**Fraser Planning Commission Agenda
City Council Chambers
33000 Garfield, Fraser, MI 48026
Wednesday, November 6, 2024 @ 7:00 p.m.**

Site Plan Review Summary

Site Plan Dated 8/12/2024
City of Fraser, Michigan

Reference: Site Plan Review

MISTER CAR WASH
STORE # MI 1454 FRASER
SITE PLANS
LAYOUT PLAN

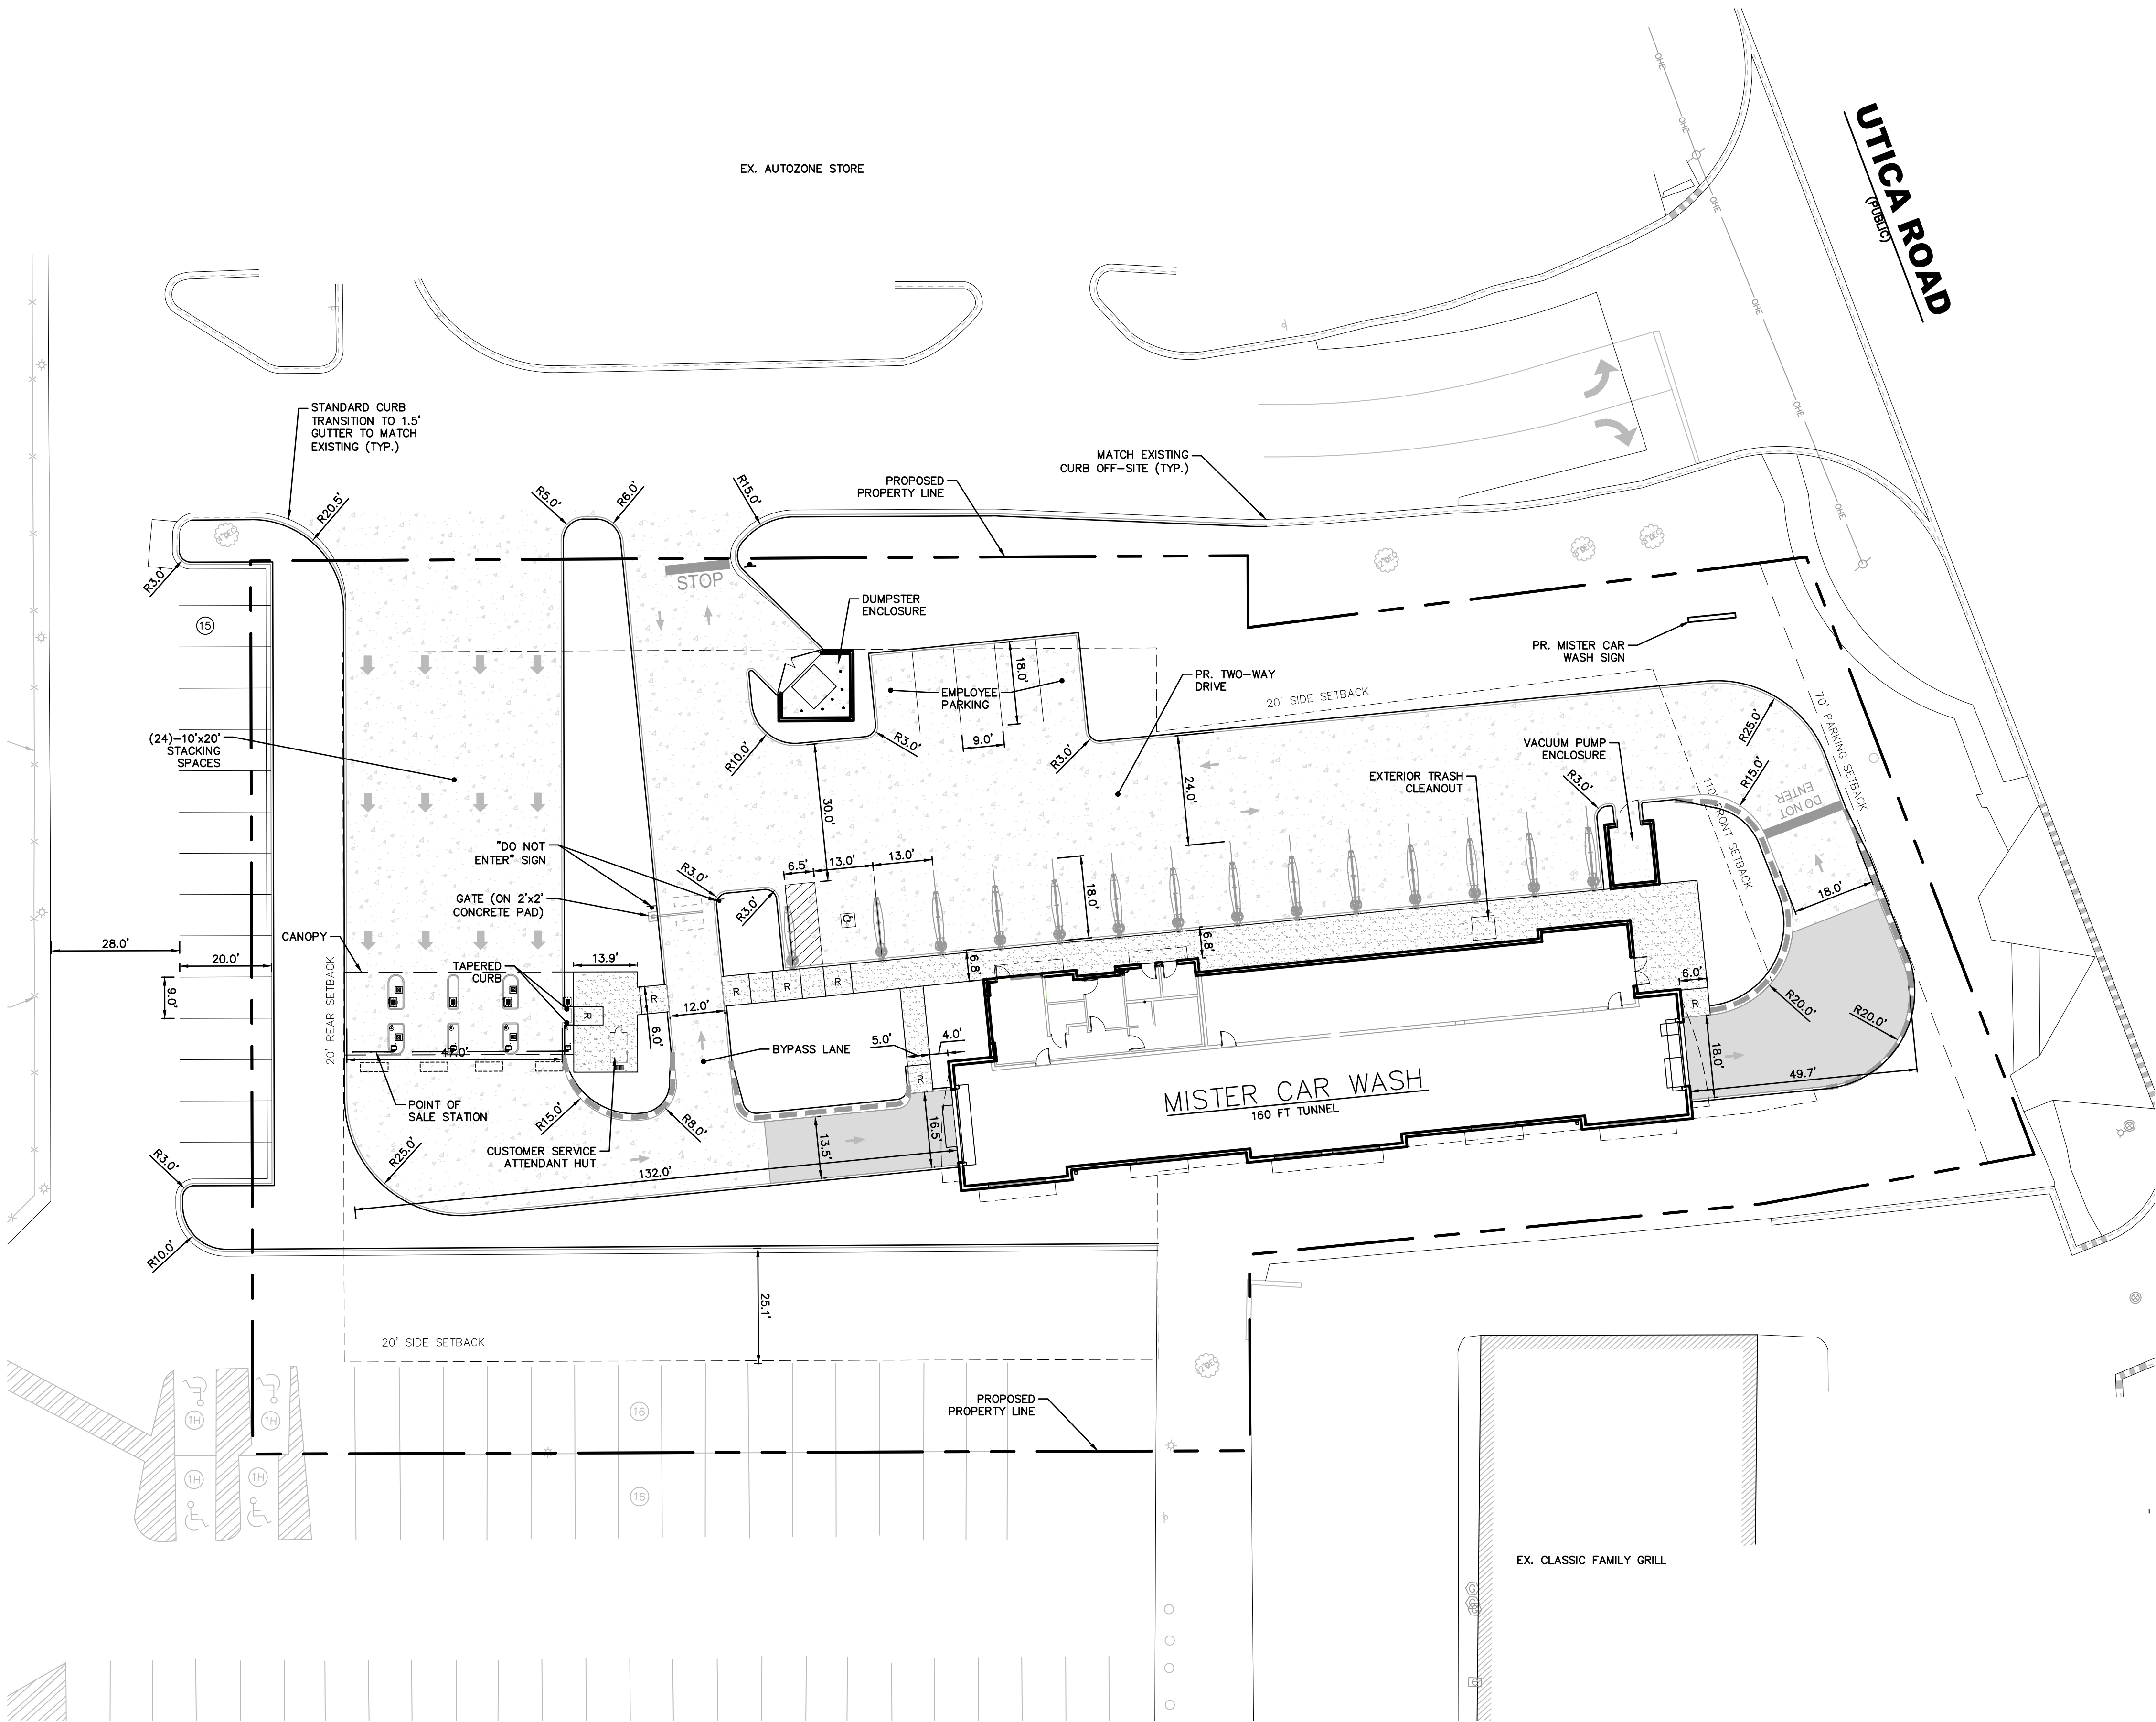
We also note that the proposed property line to the south includes 17 parking spaces from the Meijer parcel. These 17 spaces were not included in the recent 8- space parking reduction granted at the September 5, 2024 ZBA meeting. If the property line remains as proposed, Meijer will need an additional parking reduction variance and site plan amendment.

***We note the parking calculations to not appear to count the vacuum stalls as parking. Additionally, there appear to be discrepancies between the calculations provided and the site plan. For example, they indicate providing 4 employee spaces, but show 5 on the site plan. This is not a concern because they are meeting the minimum required still but should be corrected.**

The site plan indicates 9x18 feet stalls for employees, and 13x18 feet stalls for the vacuum parking stalls, with a 24-foot maneuvering lane. **The applicant shall revise the parking stall lengths to comply with one of the listed parking patterns in Sec. 32-94(2).**

The proposed plan shows one point of ingress that is 47 feet wide. The second point of ingress and egress (east driveway) is not dimensioned. **We defer to the applicant to provide this dimension, which must be at least 30 feet wide.**

1. *The building height needs to be 30 ft or less.*
2. *The proposed property line needs to be adjusted so that it does not remove required Meijer parking spaces, or a variance for the extra parking needs to be approved on the Meijer site.*

5. *The parking stall dimensions shall meet the required standards.*
6. *The parking calculations need to match the parking spaces shown on the site plan.*

7. *The eastern point of ingress and egress must be specified and must meet or exceed 30 feet in width.*
8. *The loading space must be identified, and any side loading configuration must be approved by Planning Commission*

MISTIER CAR WASH
STORE # MI 1454 FRASER
SITE PLANS
PRELIMINARY GRADING PLAN

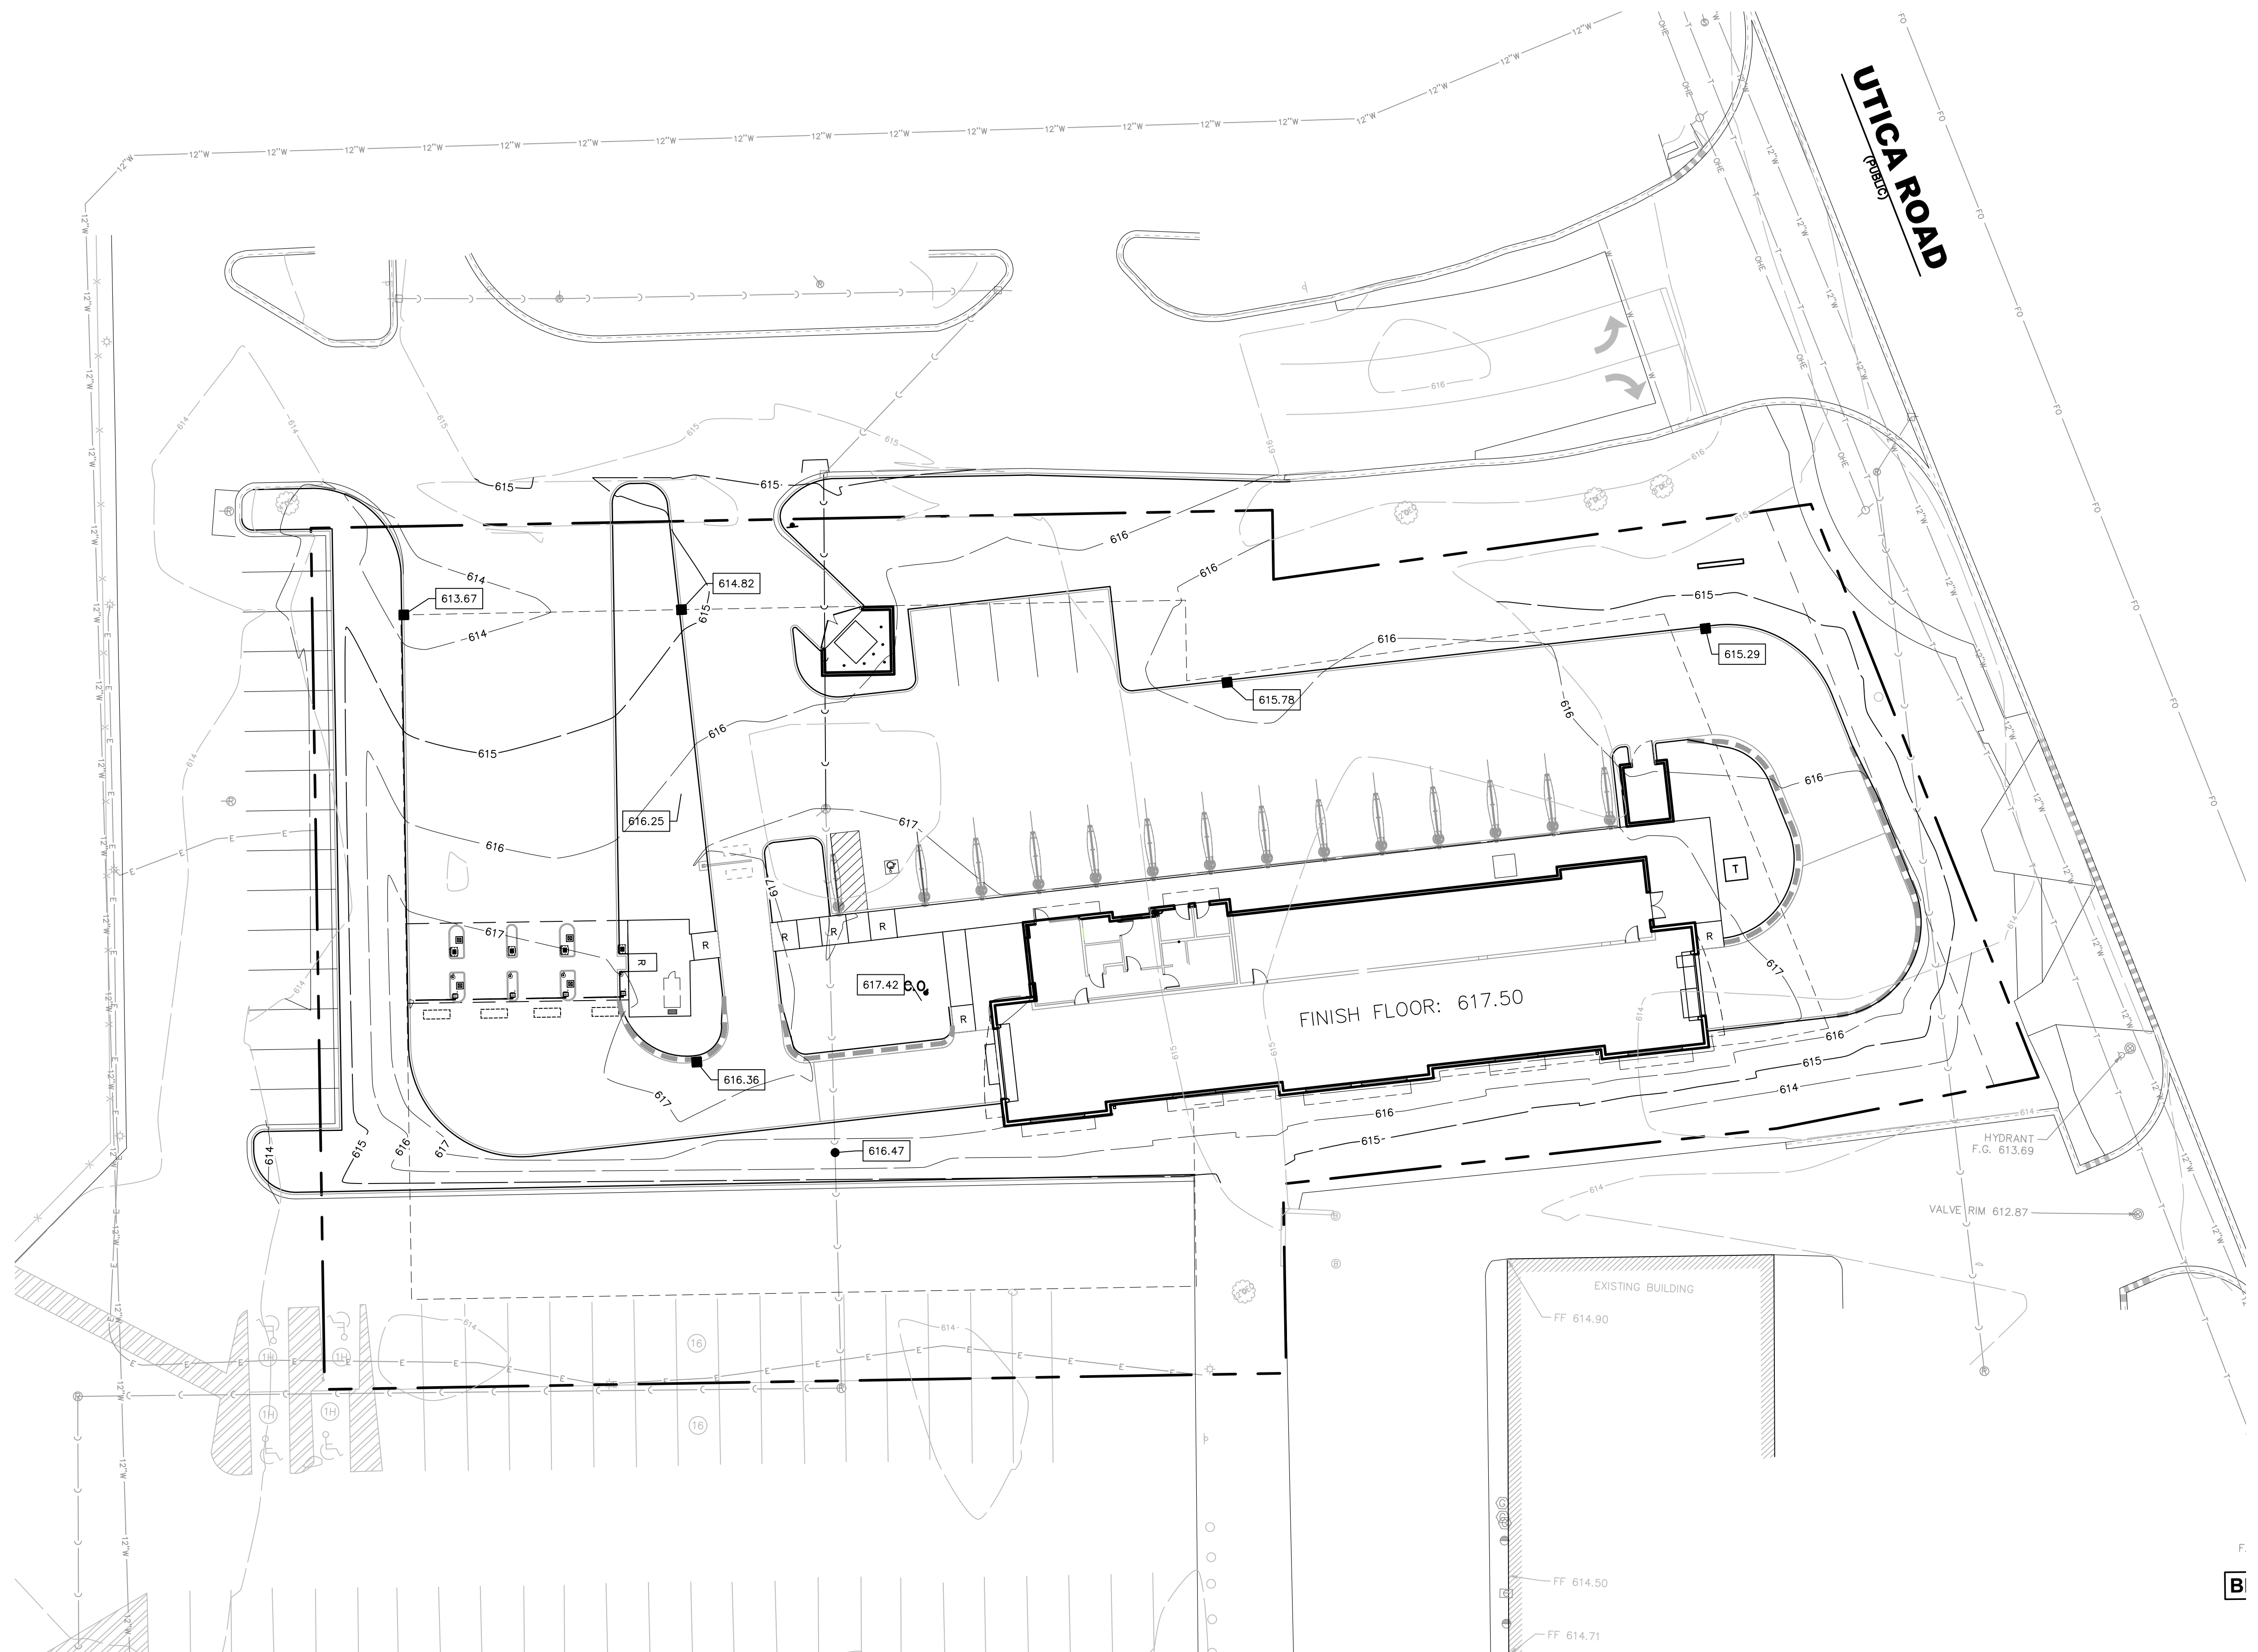
4. Preliminary grading plan suggests that surface drainage is directed off-site. Surface run-off shall be maintained on-site to the extent feasible. This can be reviewed during engineering phase.
